**PERRY NUCLEAR POWER PLANT**

August 31, 1995  
PY-CEI/NRR-1968L

Perry Nuclear Power Plant  
Docket No. 50-440  
10CFR50.54(a)(3) Review Of Changes In Administrative  
Controls For Procedures and Instructions

17.2.15.3.2 Director, Perry Nuclear Assurance Department

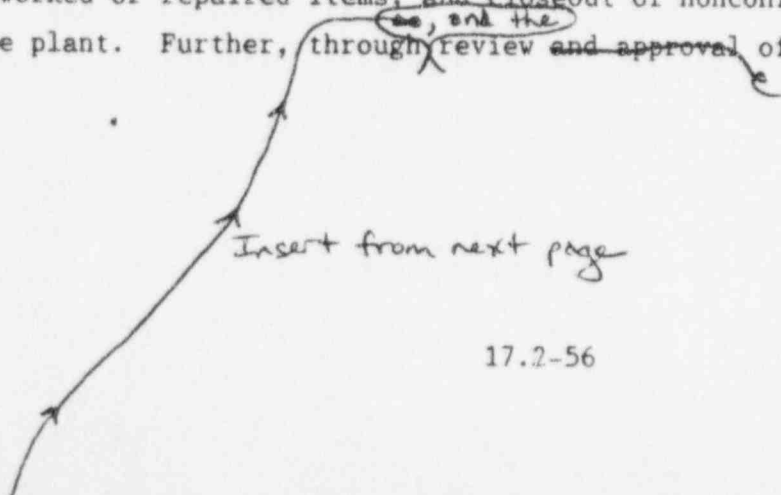
The Director, PNAD, is responsible for the identification, documentation, and segregation of nonconforming items at the plant. This director is responsible for reviewing nonconformance dispositions for adequacy, providing approval, performing inspection of replacement, reworked or repaired items, and closeout of nonconformances generated at the plant. Further, through ~~review and approval~~ <sup>review, and the</sup> of plant administrative

control procedures and vendor/contractor QA program audits and inspections, the Director, PNAD, shall verify the adequate implementation of nonconformance control both at the plant and in the

SECTION 17.2.15.3.2 "Director, Perry Nuclear Assurance Department"  
PAGE 17.2-56 and 56a  
CHANGE The Director, PNAD is responsible for the identification, documentation and segregation of nonconforming items... Further, through vendor/contractor QA program audits and inspections, and the review of plant administrative control procedures, the Director, PNAD shall verify...
